RE: **P.Z. 09-2022 Valley Village (Stock & Associates):** A request for a zoning map amendment from a “C8” Planned Commercial District to a “PC” Planned Commercial District for 10.9 acres located on the northwest corner of Chesterfield Airport Road & Wings of Hope Blvd (17W620312, 17W620334, 17W640091).

RE: PZ 09-2022 Valley Village – Response to Departmental Letter
(Stock Project No. 215-5542.8)

We are pleased to offer the following written responses to your comments contained within your departmental letter, dated 9/20/2022.

PRELIMINARY DEVELOPMENT PLAN FOR:
VALLEY VILLAGE
 18363, 18369 & 18375 CHESTERFIELD AIRPORT ROAD
 CHESTERFIELD, MISSOURI 63005

SHEET NO.: C1.0

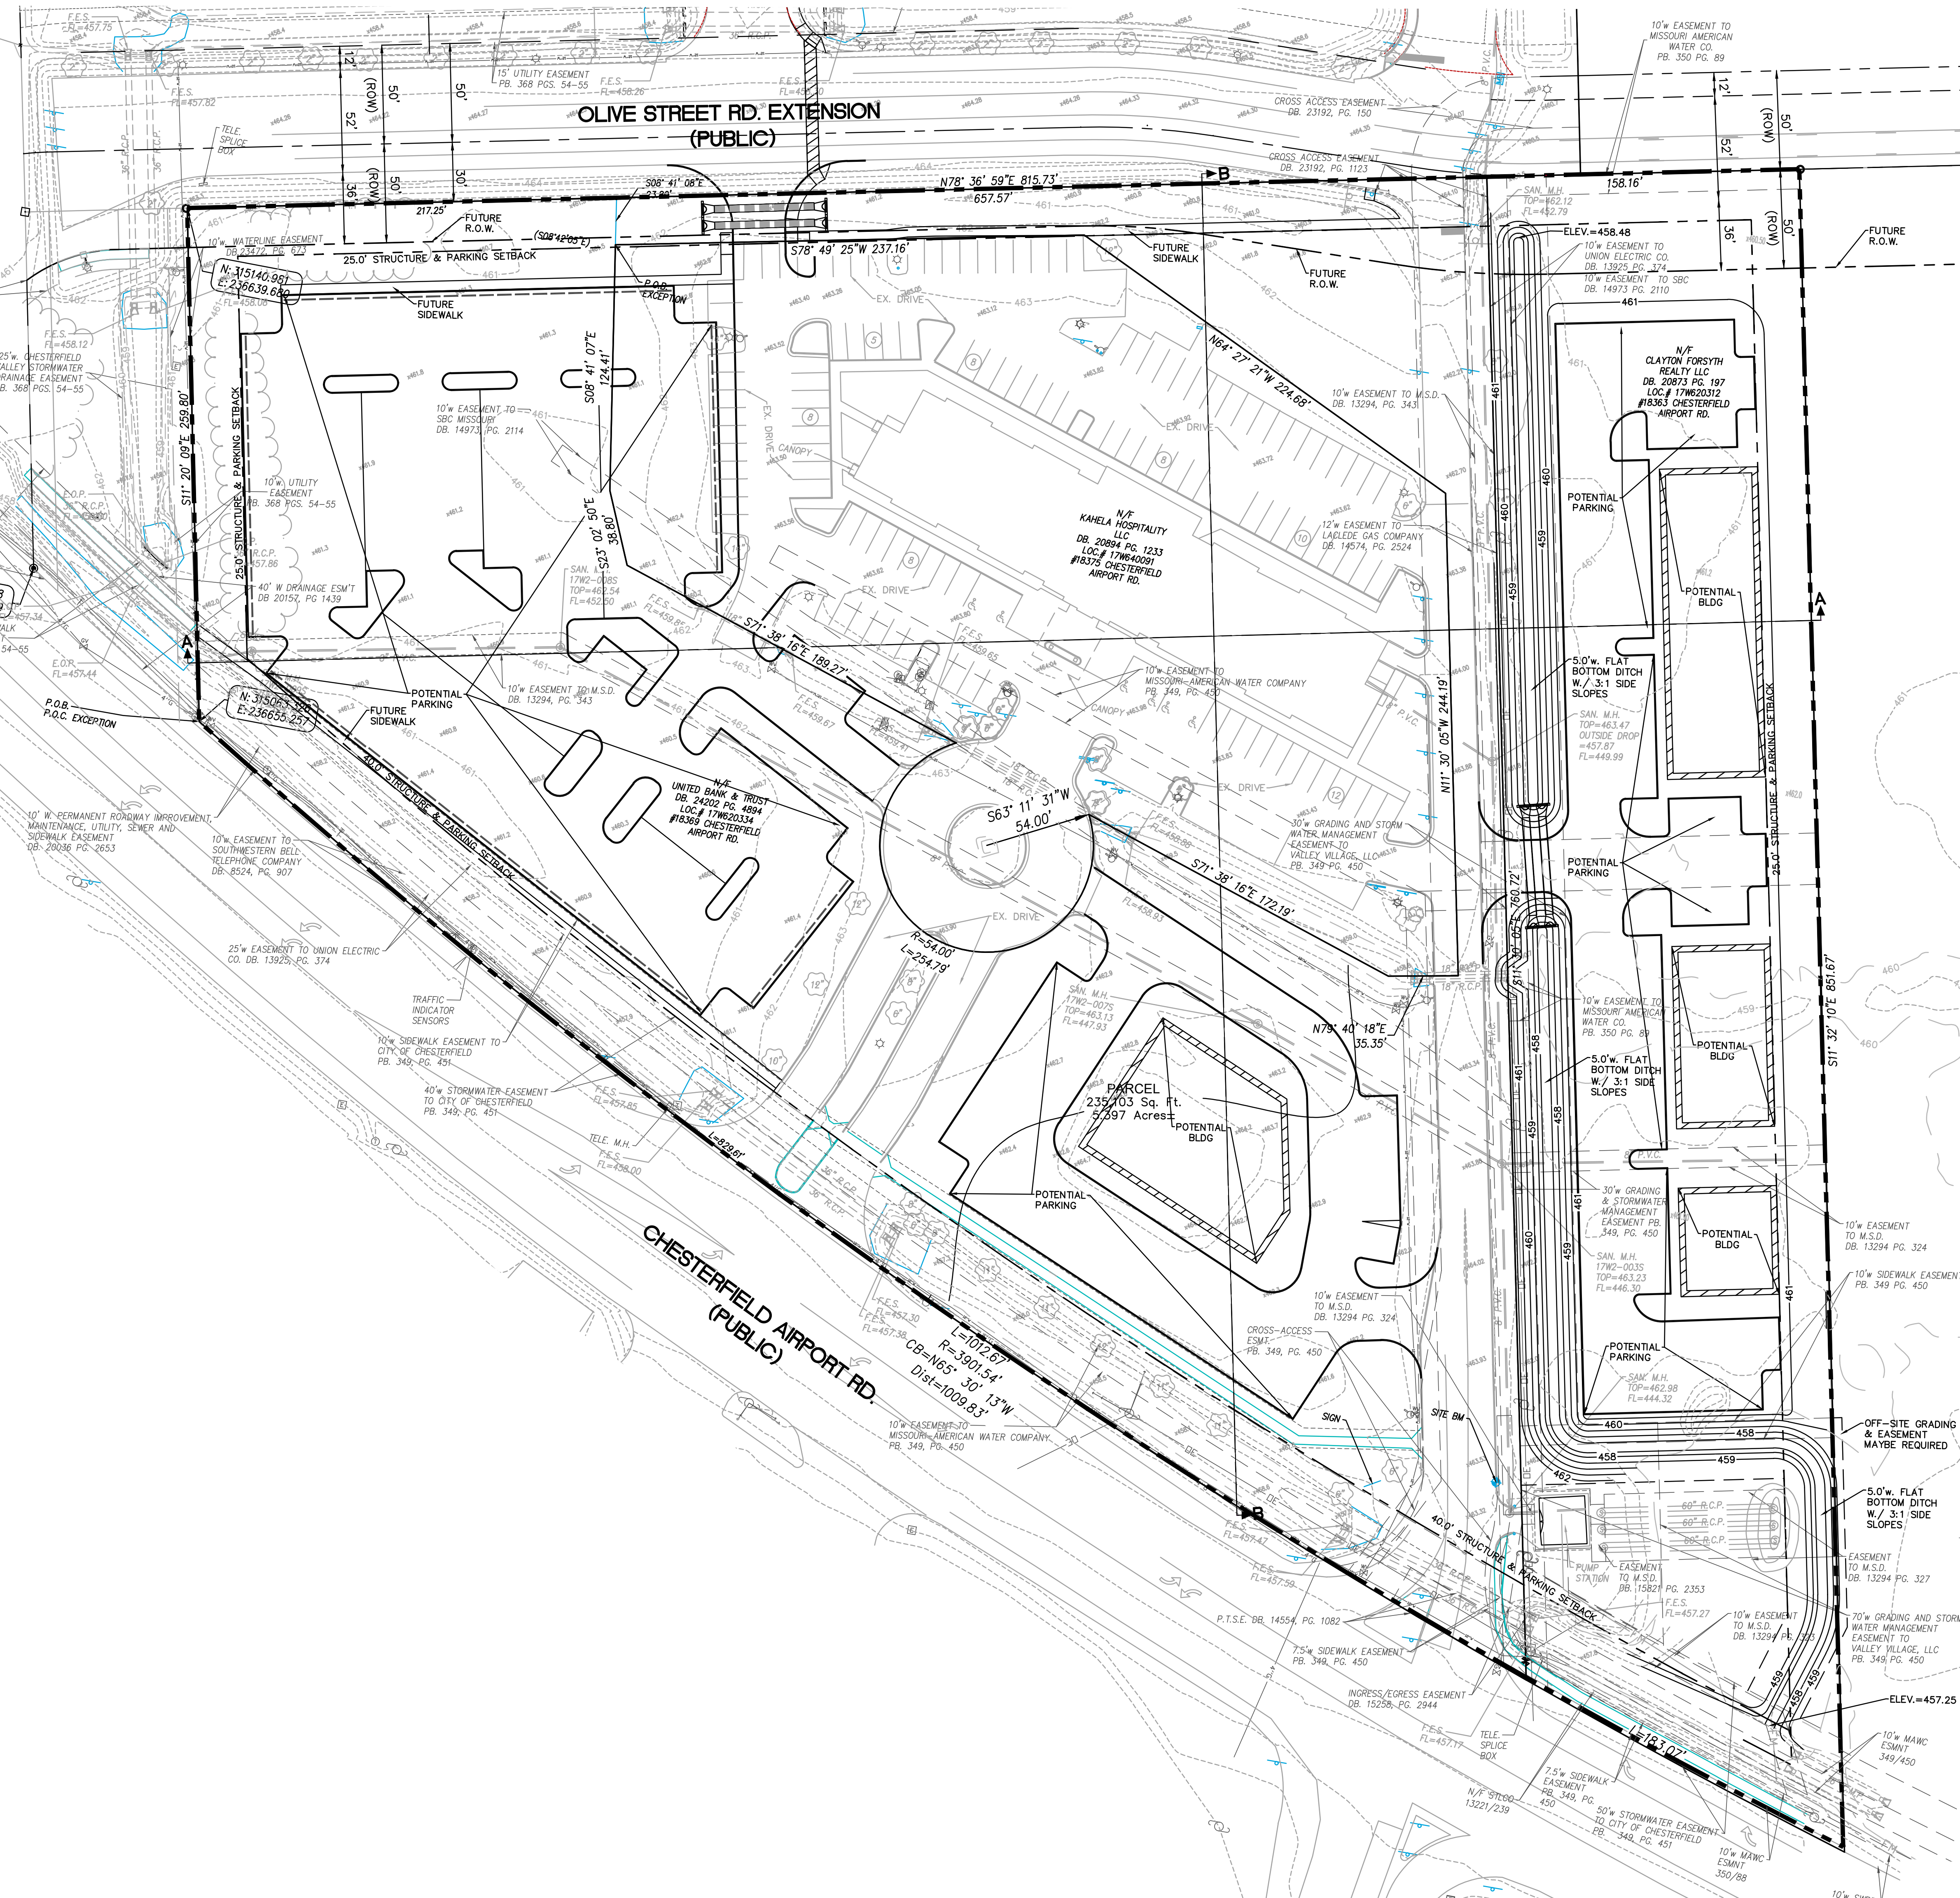
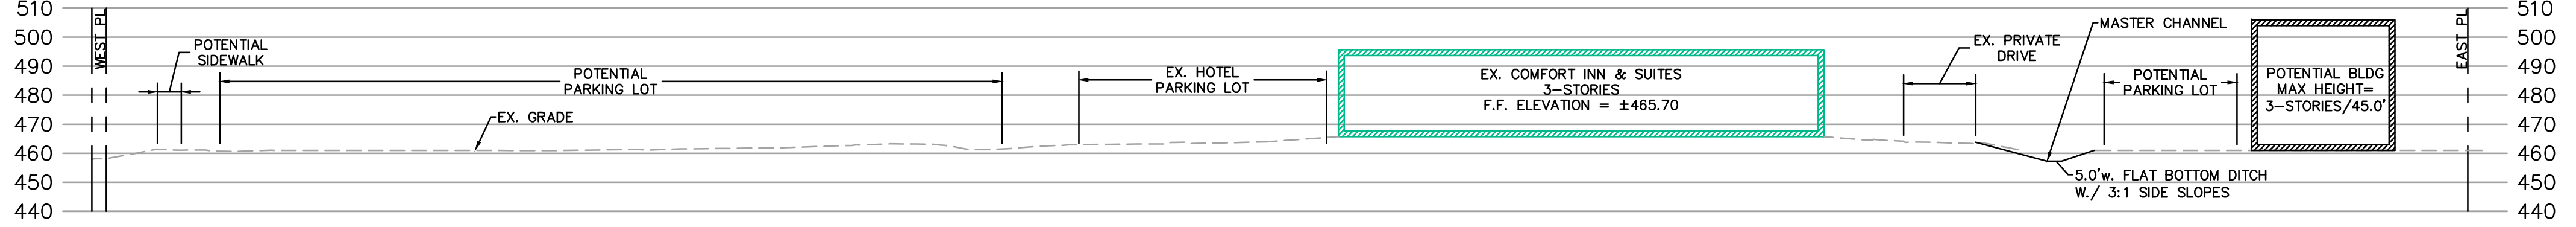
1. Show the property setbacks, parking setbacks, easements, and dedications in the plan.

2. Label the internal existing roadways.

3. A 5' wide flat bottom ditch with 3H:1V side slopes is required east of the existing private drive (see attached excerpt from the Chesterfield Valley Storm Water Master Plan). Please show the future channel area on the plan and update Section A-A to reflect channel location as well.

4. Storm water culverts will be required under the access drive to the eastern portion of the site to accommodate the Master Plan Channel. Please show the culverts.

5. Add proposed sidewalk locations along Chesterfield Airport Road and Olive Street Road to the plan.

6. The southernmost proposed driveway on the west side of the internal access road may not meet the minimum corner clearance requirement from Chesterfield Airport Road. Please review City Code Section 405.04.100 (F) Figure A2 and adjust the driveway location to meet the minimum clearance requirement based on the corner radius from Chesterfield Airport Road to the internal access road. The minimum corner clearance is 120 feet from major arterials.

8. Show/label the future ROW dedication for Olive Street Road.

Response: Added to the Plan.

Response: Added to the Plan.

Response: Added to the Plan.

Response: Added to the Plan.

Response: Added to the Plan.

Response: Southernmost proposed driveway has been shifted north to meet the City's access management clearance requirements.

Response: The maximum throat depth we are able to achieve is 59.0' feet. An 80.0' throat would conflict with the existing hotel parking and drive aisle.

Response: Added to the Plan.
